## BRIEFING SUMMARY SHEET

DEVELOPMENT ASSESSMENT CASE NUMBER: CD-2015-0017 – Cascades I at Onion Creek

Presentation of a Project Assessment Report for the Cascades I at Onion Creek Planned Unit Development, also known as Cascades Municipal Utility District No. 1, located at 11601, 11809, 11811 and 11819 South IH-35 Service Road Northbound, within the Onion Creek Watershed.

## MASTER REVIEW REPORT

# PARKLAND AND OPEN SPACE EXHIBIT CASCADES MUNICIPAL UTILITY DISTRICT 1

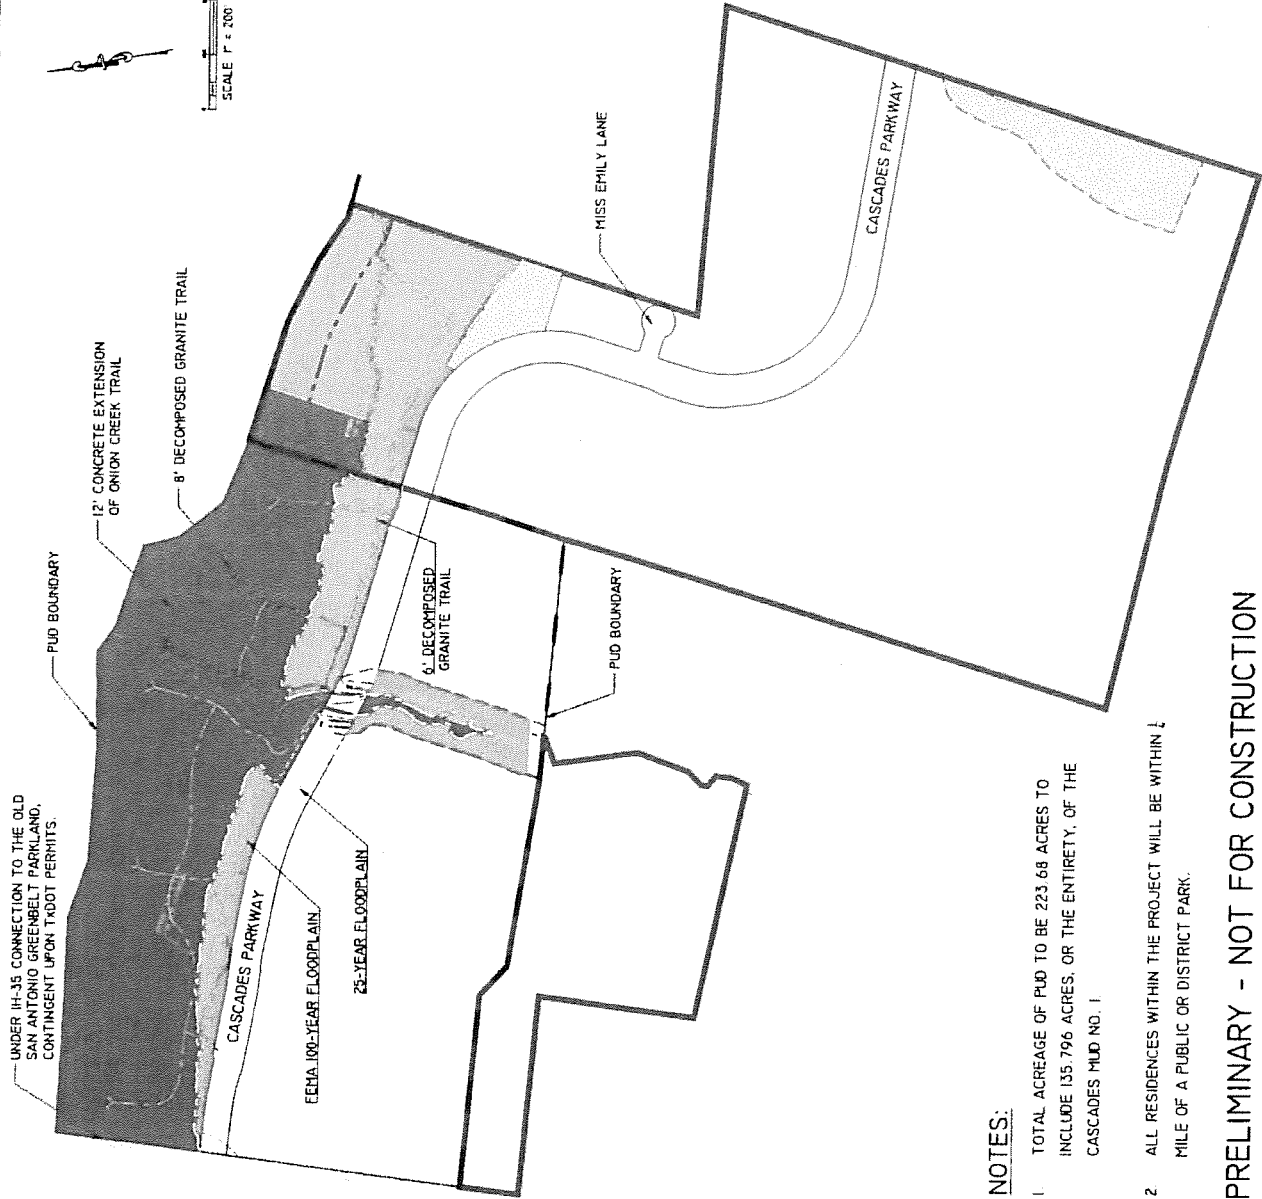
1) Provide a Park Plan Exhibit similar in size to the Land Use Plan. On that plan include floodplain, CQWZ, wet ponds, CEFs (if applicable) CEF buffers (if applicable) and approximate locations of trails discussed in the MUD Consent Agreement Exhibit O, first paragraph. The trail line can be stated to be approximate but it should show an alignment outside any CEFs and CEFs buffers. The trail lines should show connectivity between the parkland and the adjacent northern neighborhood and the neighborhoods to be constructed within the PUD. Specifically, show how the trails will bring MUD District residents to the parkland and trails across Cascades Parkway.

- On the Park Plan Exhibit, the 51.76 plus acreage should not include any of the amenity centers (private parks not open to the public). Please put the 51.76 acres in one color and the amenity centers or private parks not open to the public in another color. The Community Center should be colored the same as Amenity Centers if it is not open to the public.

- The PUD Summary Project Superiority states that parks will be provided within one-mile of all residents. This is **not** superior because Council resolution calls for parks within the suburban area to be within ½ mile of all residents. In addition, the City already has parkland within one mile of all these residents just east of I-35 in the Old San Antonio Greenbelt. In addition, the whole development is not one mile across. Either take this item out or provide superiority by adding parkland within ½-mile or ¼-mile (infill standard showing superiority) of all residents and state that. These can be private parks for resident use only or MUD district parks open to the public. If this goal will be provided for superiority, place a note on the parks plan exhibit that says additional public or private parkland will be provided within ¼-mile of all residents.
